Re: 25-15W – CT Route 44/ Boston Turnpike – List No. R04732

Proposed 3-lot subdivision

Review Memorandum

*WP 25-15  
TM Penney comments 7/14/25*

SUBDIVISION PLAN

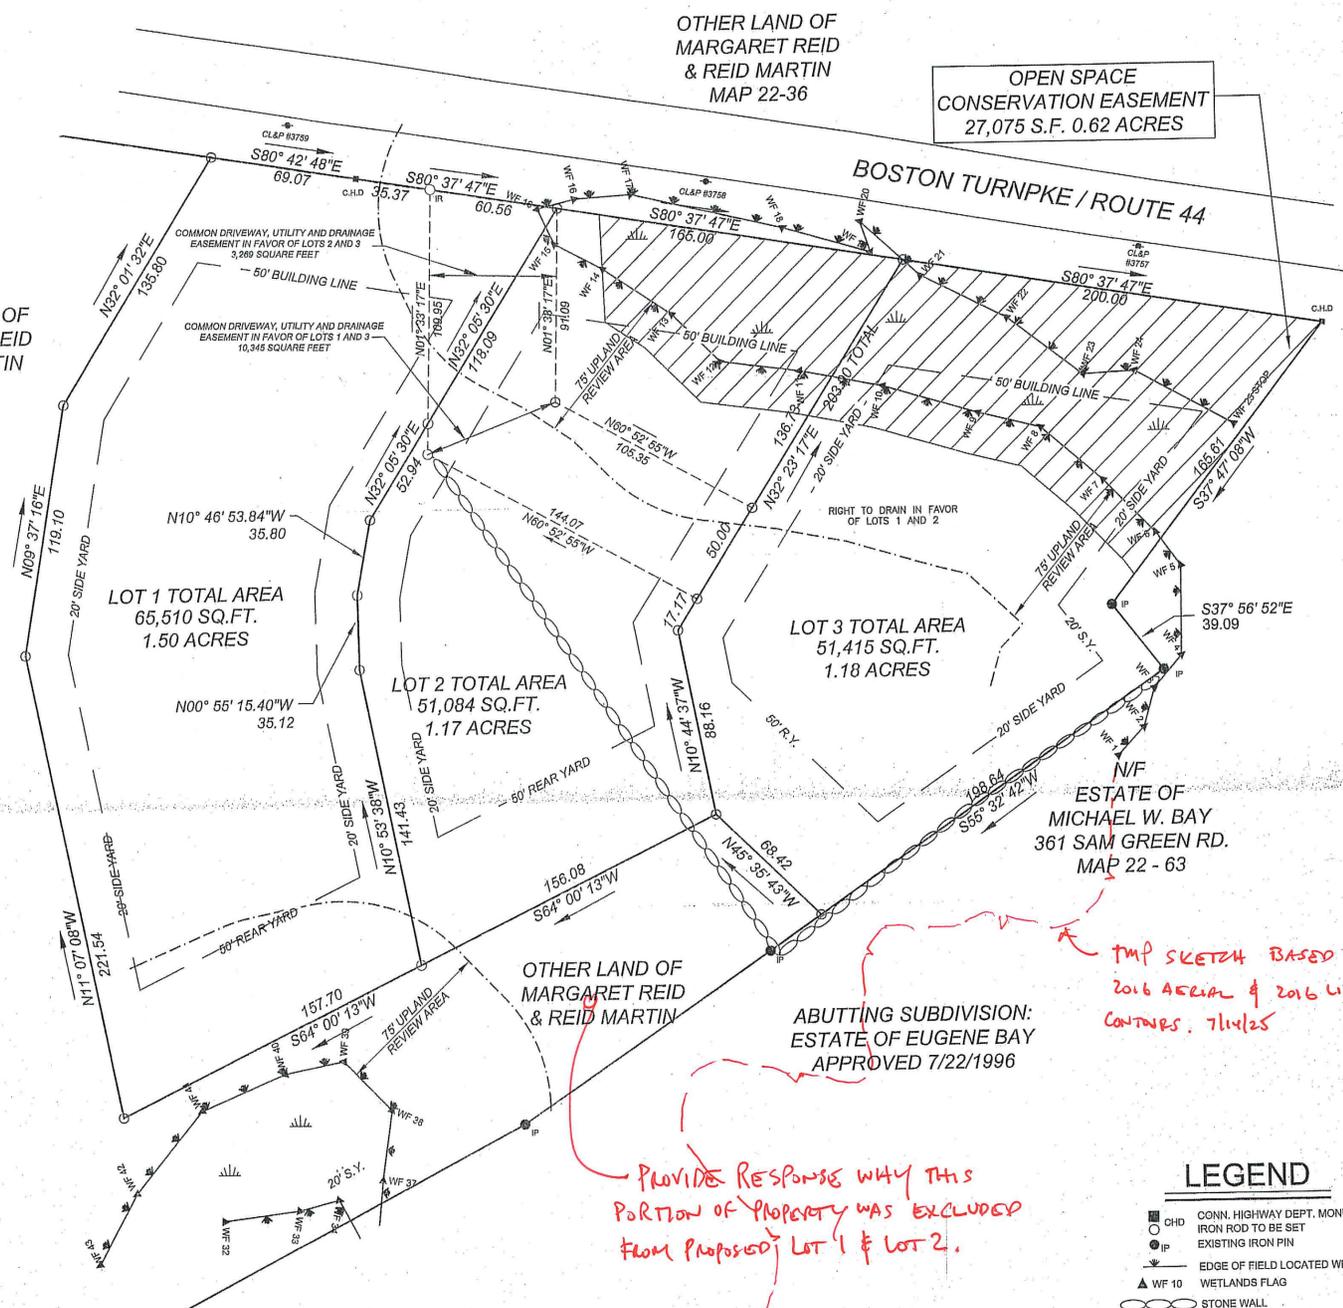
*BASED ON CONVERSATIONS W/T.P. JANA ROBERSON, THIS "OTHER LAND OF" SHOULD BE CONSIDERED PART OF THE SUBDIVISION. THEREFORE APPLICANT WILL NEED TO DUPLICATE ENTIRE PARCEL AND WETLANDS.*

*IT IS MY OPINION THE APPLICATION SHOULD HAVE A REPORT BY THE WETLANDS SCIENTIST TO DISCUSS WETLAND CONDITIONS AND HOW APPLICATION PROVIDES MITIGATION IMPROVEMENTS TO ELIMINATE WETLAND IMPACTS.*

STORMWATER MANAGEMENT PLAN

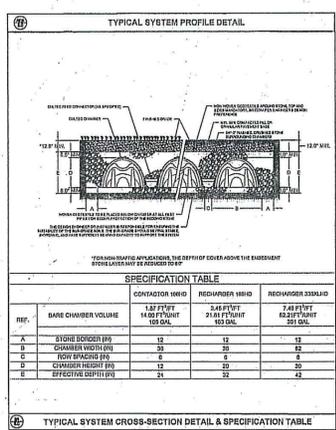
CL&P #3759  
ADD EXISTING TOPO  
ADD PROPOSED TOPO

LOT 2  
IT APPEARS AS IF DRIVEWAY IS LOWER THAN INFILTRATION TRENCH. PROVIDE MORE SPOT ELEVATIONS THIS DOESN'T CORRESPOND W/ DRAINAGE COMPS. DOES INFILTRATION TRENCH OVERFLOW TO GRASS SWALE?

PROVIDE RESPONSE AS TO WHY SEPTIC CANNOT BE SHIFTED OUT OF U.R.A.

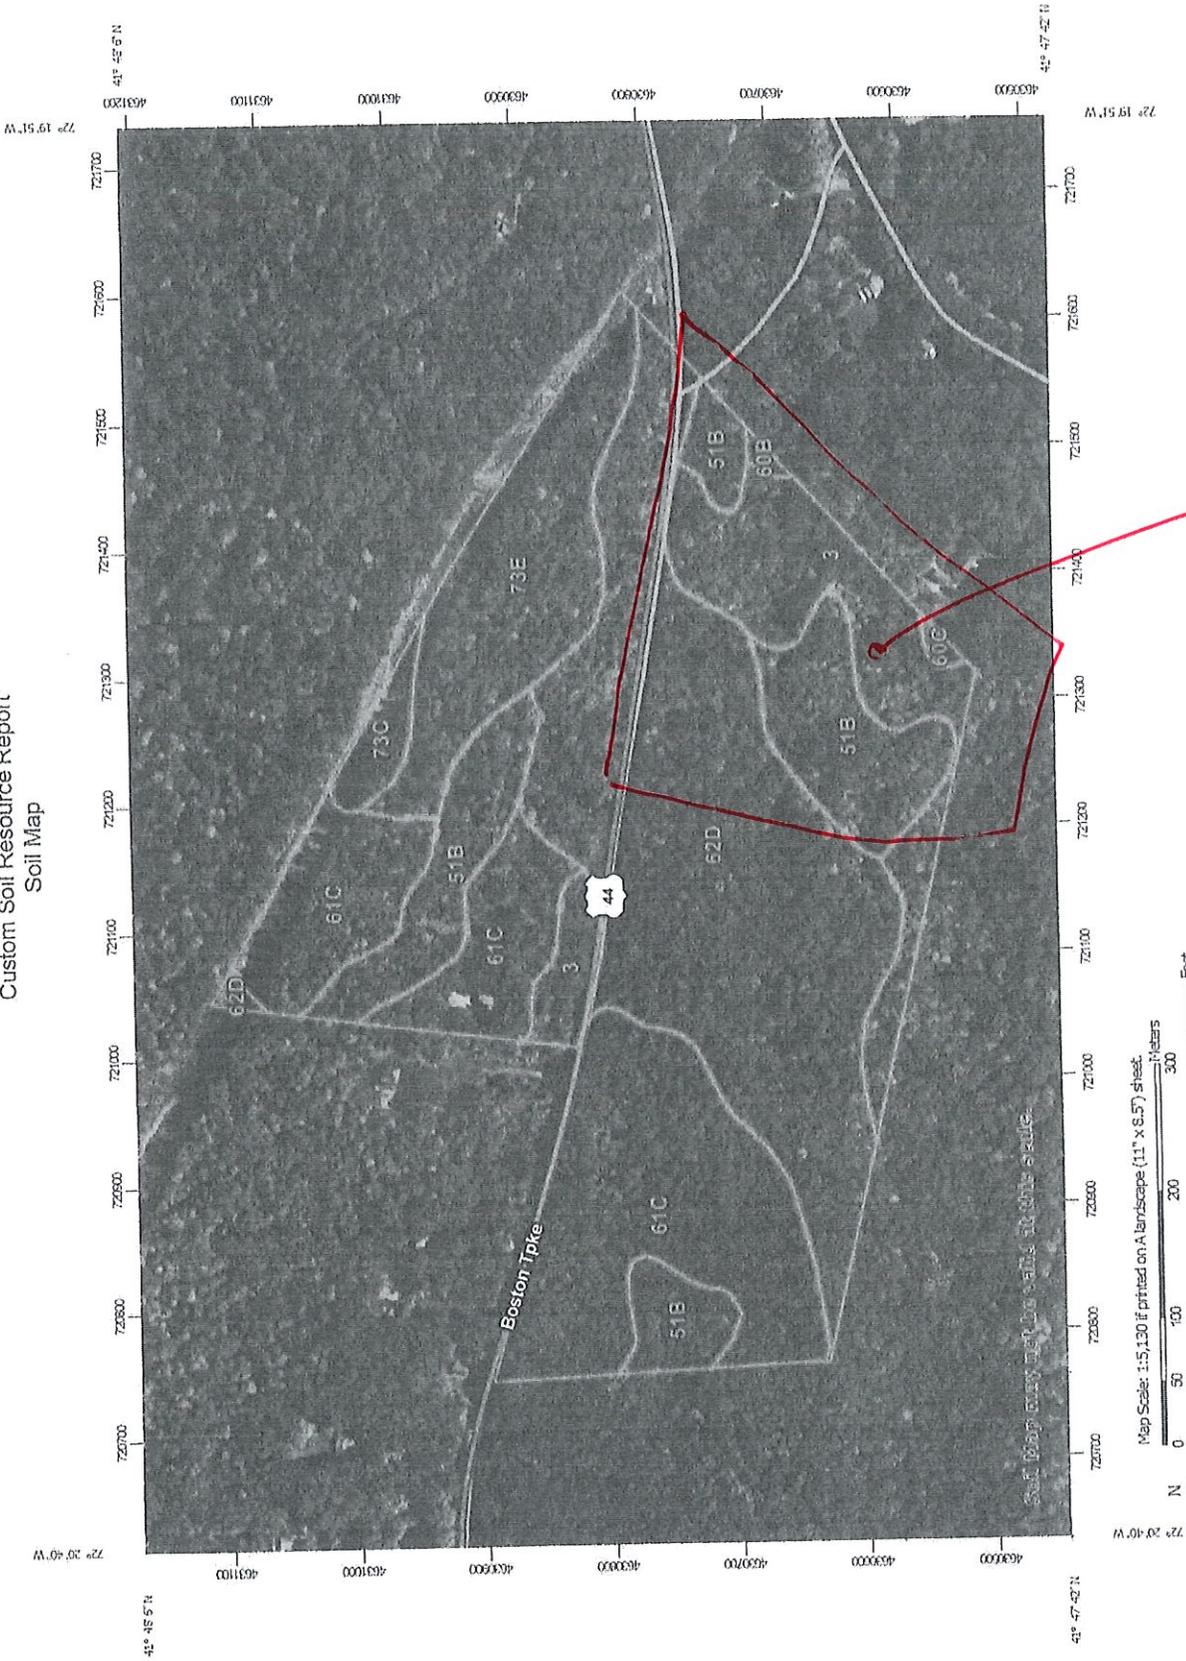
\* PROVIDE COMMENT ON HOW SITE ADDRESSES PEAK STORM EVENTS.  
**Project Overview:** This narrative is intended to describe the erosion and sediment control methods and the stormwater management measures to be used during the construction of a 3 lot residential subdivision and its associated buildings and driveways. Soil erosion and sediment controls will be provided to control impacts during construction and shall be in conformance with the methods outlined in the *2024 Connecticut Guidelines for Erosion and Sediment Control Manual*. The stormwater management measures are planned to mitigate the increase in impervious areas resulting from the proposed construction and will provide collection, treatment and infiltration of the first 1.3" of rainfall (Water Quality Volume – WQV) in a manner consistent with the *2024 Connecticut Stormwater Quality Manual*.

✗ PROVIDE A PLAN/FIG. W/ PROPOSED IMPERVIOUS COVERAGE DEPICTED

PROVIDE BACKUP TO THIS NUMBER? (4.25 AC)

PLAN CALLS FOR 15" WHICH IS CORRECT?
